VANDERVEEN-TRANS-PP80 corrections. Vs. March 2025

[See *audioXpress* May-2023 pp. 21-28]

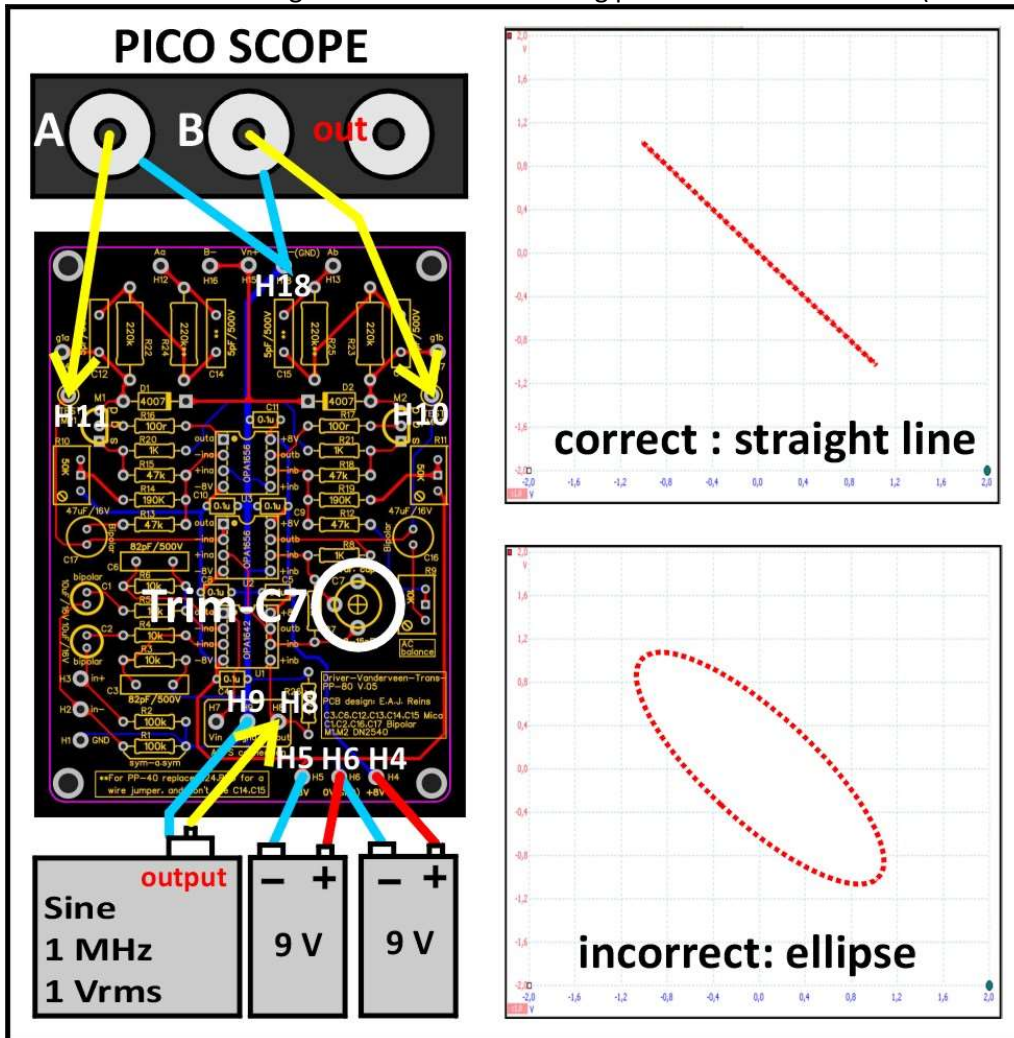
- 1) **R12 is wrongly indicated ONLY on the driver-PCB.** There its value reads 47kOhm. The correct value is: **R12 = 41k2**. In all circuit diagrams and the BOM this value is mentioned correctly.
- 2) **The START-UP procedure contains a mistake in step-5.** The correct version is:
 5. Check on the driver-PCB **on opamps-1 and -2** at their opamp-outputs (pin-1 and pin-7) to read less than 5 mVdc with reference to ground.
- 3) **Figure 7 contains a number mistake where to measure the phases of the driver signals:**
Please see the correct figure below: the measuring positions are H11 en H10 (not H17)
